**Subject:** Fwd: City of Missoula Standards and Specifications Manual Update

Subject: Re: City of Missoula Standards and Specifications Manual Update

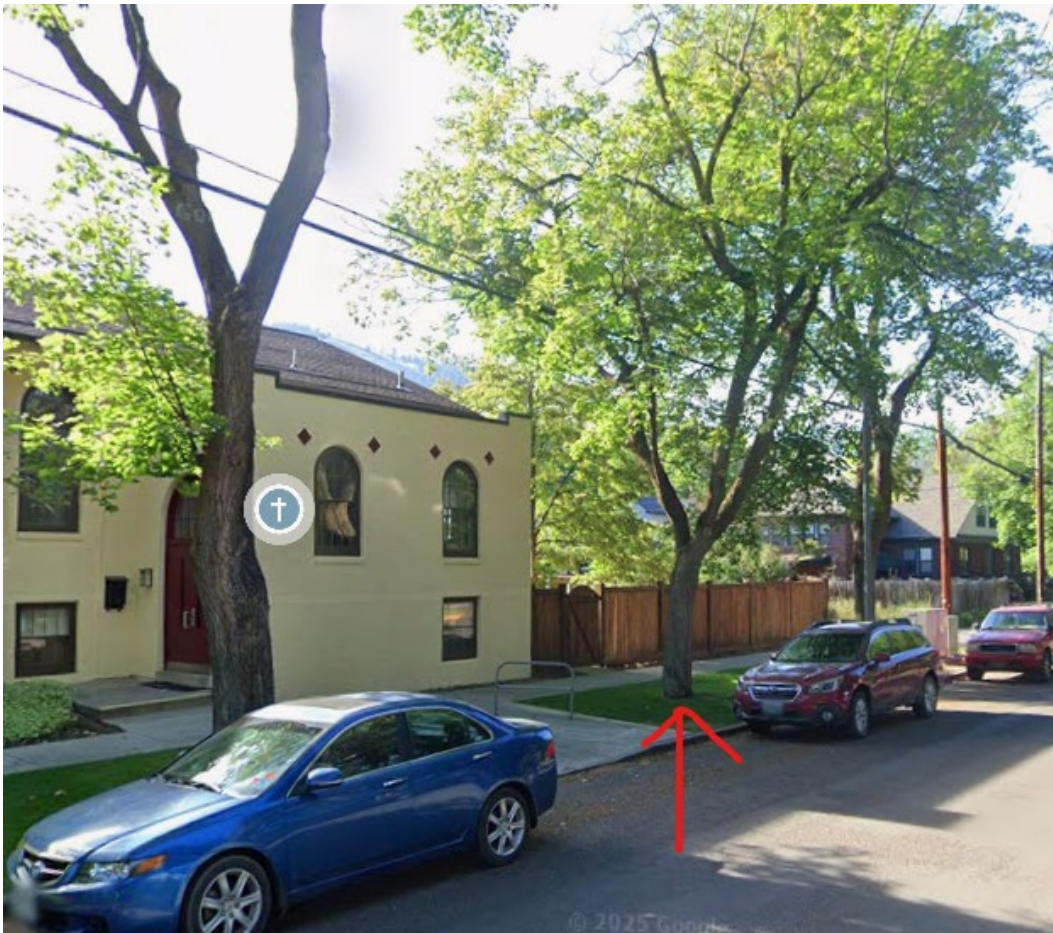
Page 7-29 has trees allowed to be planted in a visibility triangle at an intersection. I recommend that trees not be allowed in the visibility triangle because when they are younger they block oncoming traffic. I was in an accident on 11th due to this very case. See picture below. (Eye level) There is a stop sign on this intersection now but the tree (on the left) still blocks your view of oncoming traffic and is a hazard even if stopped on 11th. You should have clear visibility from 30" to 6' above grade for clear visibility to prevent accidents.

I think Class 1 trees should also be allowed when the building is adjacent to the Public sidewalk. The zoning code wants buildings next to the boulevard sidewalk and no trees should not rub against buildings especially boulevard trees as the building owner is not allowed to cut the branches off of them. If the front yard setback is less than 10 feet on the adjoining property then a Class 1 tree should be acceptable.
